Brownstein | Hyatt
Farber | Schreck

November 22, 2010

RE: OMEGA CHEMICAL CORPORATION – Operable Unit 2
EPA #: CAD042245001
Comment on Proposed Plan for the OU-2 Groundwater Contamination for the Omega
Superfund Site and the Omega Superfund Site Remedial Investigation/Feasibility Study

Figure 1-4
Composite PCE Distribution
Omega OU2 Feasibility Study

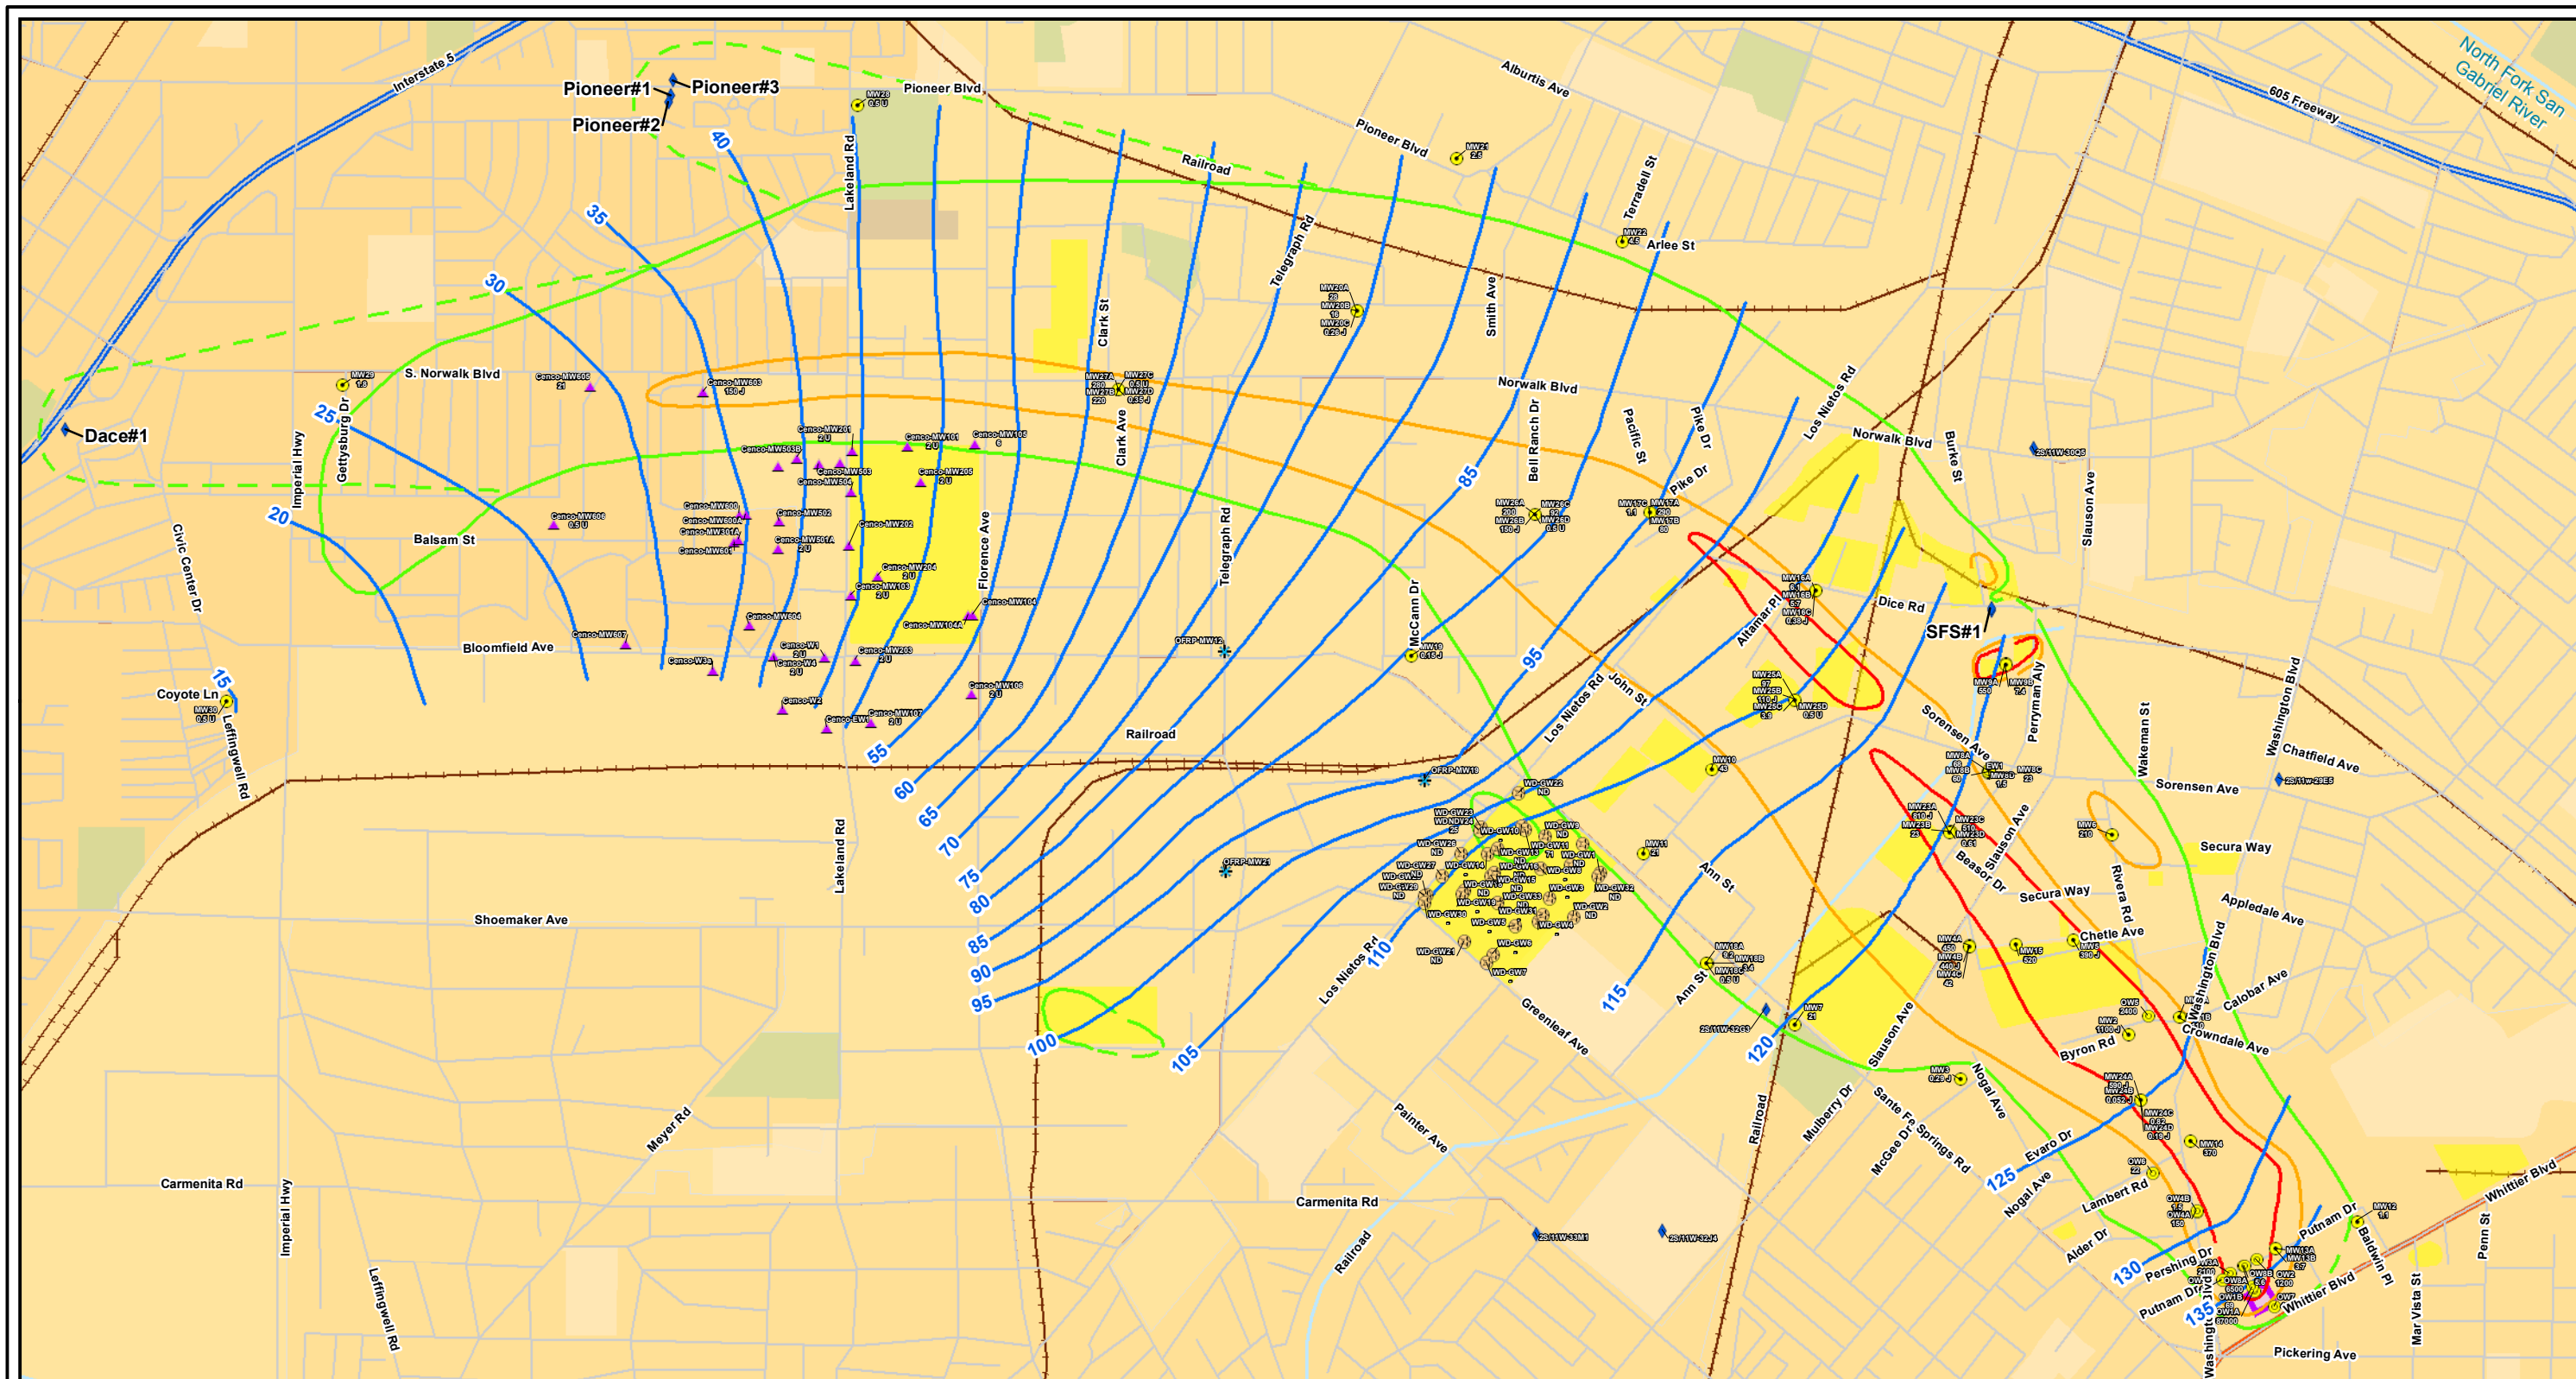
⁶¹ See FS Page 1-10, 1-12, 2-1, Figure 1-4 (showing use of 2007 data

Figure A-13
Capture Zone Map
Pumping Scenario with Leading Edge Extraction
Omega OU2 Feasibility Study

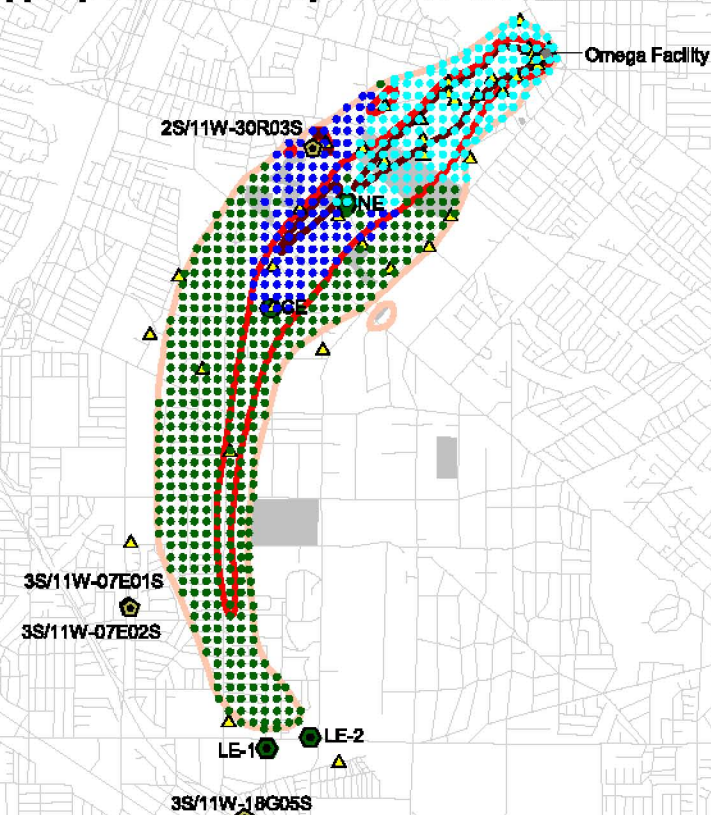
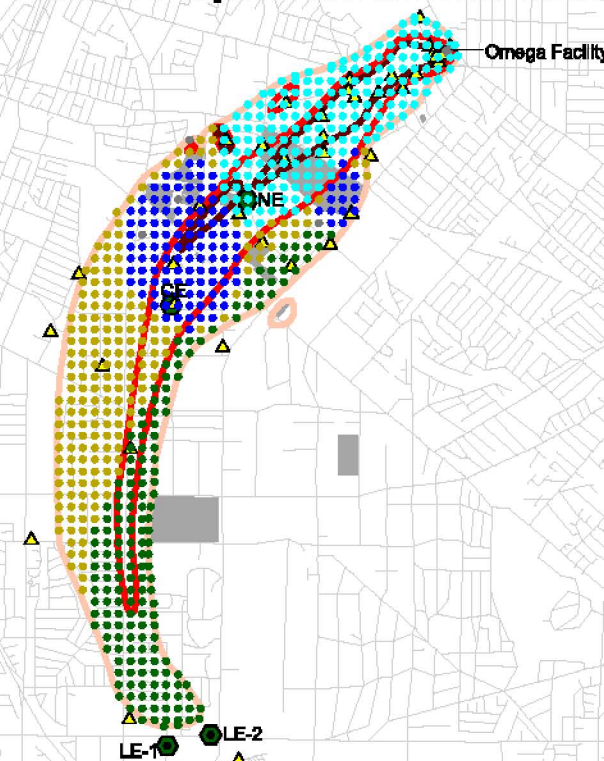
Capture zone modeling conducted for the FS shows that approximately one-third of the OU2 plume in the middle and lower portion of the contaminated zone will continue to be captured by the downgradient GSWC wells. FS Report Figures A-13 and A-14 show the capture zones for the leading edge and plume-wide pumping alternatives, respectively including GSWC wells Pioneer 1 (3S/11W-07E01S), Pioneer 2 (3S/11W-07E02S), and Dace 1 (3S/11W-18G05S). Under both alternatives, these figures show that these three wells will continue to capture the western one-third of the OU2 plume in the middle and lower portion of the contaminated zone.⁷⁷

Capture zone modeling conducted for the FS shows that approximately one-third of the OU2 plume in the middle and lower portion of the contaminated zone will continue to be captured by the downgradient GSWC wells. FS Report Figures A-13 and A-14 show the capture zones for the leading edge and plume-wide pumping alternatives, respectively including GSWC wells Pioneer 1 (3S/11W-07E01S), Pioneer 2 (3S/11W-07E02S), and Dace 1 (3S/11W-18G05S). Under both alternatives, these figures show that these three wells will continue to capture the western one-third of the OU2 plume in the middle and lower portion of the contaminated zone.
